Re: Dhakal Karki Addition Minor Plat - Review #1

Halff was requested by the City of Sanger to review the Minor Plat for the Dhakal Karki Addition. The submittal was prepared by Metroplex Surveying and was received on May 20, 2025.

DATE 3/21/23
DRAWN BY RAI
SCALE 1" = 20'-0"
SHEET **S/1**

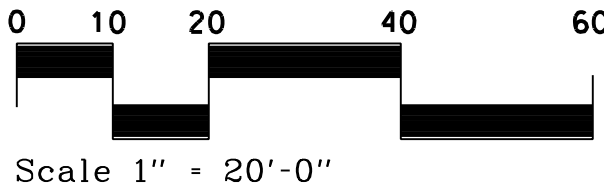
Sidewalks in commercial areas shall be a minimum width of six feet (6') or extend from the back of the curb to the building line as required by the city per § 10.106(c)(3)

Dumpster enclosure openings may not face public rights-of-way unless they are gated per § 14A-48.5.2(e).
Where is the dumpster for Lot 1?

22 spaces counted (6+10+6). Where are the other 2 provided?

Show the proposed revised plat lot lines to evaluate concept layout further.

Show curb return
